Notice of Allowability

10/534,354

SUGITA ET AL.

EXAMINER'S AMENDMENT

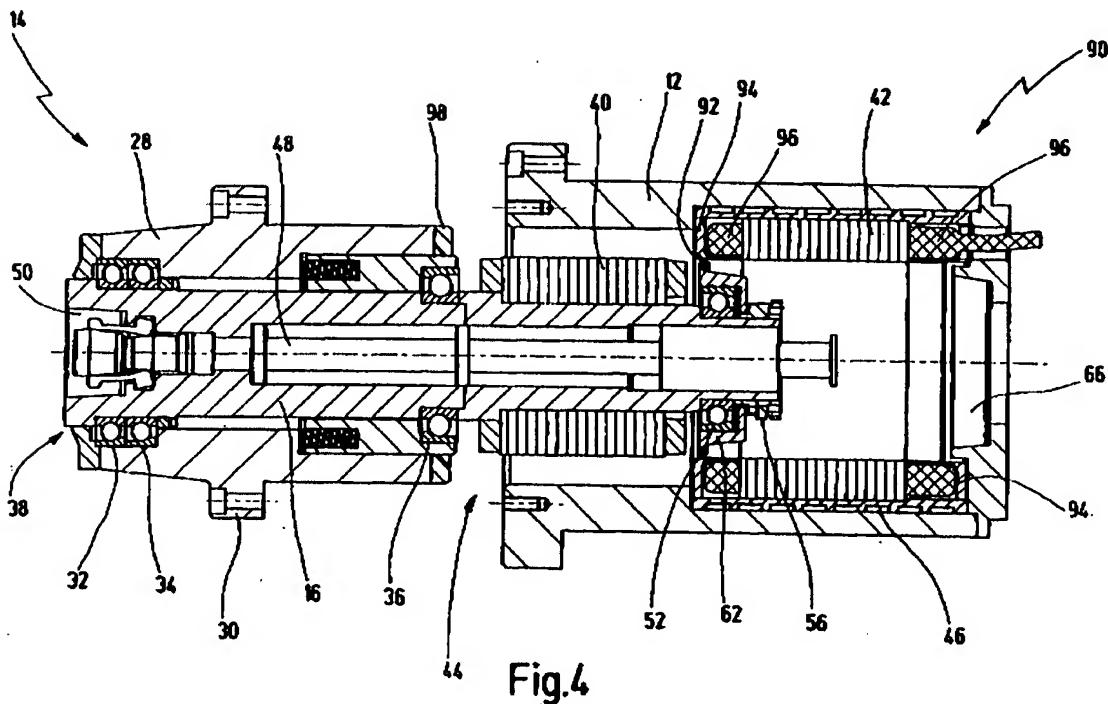
Re the diameters set forth in claim 1, see the reproduction of Figure 4 below, noting that the inner diameter of the outer cylinder 12 is larger than the inner diameter of the stator 42, and that the inner diameter of the stator 42 is larger than the outside diameter of the bearing sleeve 62.

Note also that a subassembly including the front housing 28, the rotating shaft 16, and the bearing sleeve 62 is withdrawable from the outer cylinder 12, as shown in at least Figures 2 and 4, for example.

Also, measuring gear wheel 56 is located rearwardly of the bearing sleeve 62, rotates (by virtue of its being a measuring gear and also being affixed to the rotating shaft 16, see Figure 4, 1, and English translation), has a smaller radius than the smallest or minimum radius of a non-rotating part located between the rear end of the bearing sleeve 62 and the section through the gear 56 (see Figure 1, for example, noting that the radius of the gear 56 is smaller than the minimum radius of any number of non-rotating parts located at a section of the gear, such as part 66, or the stator 42, for example, see Figure 1).
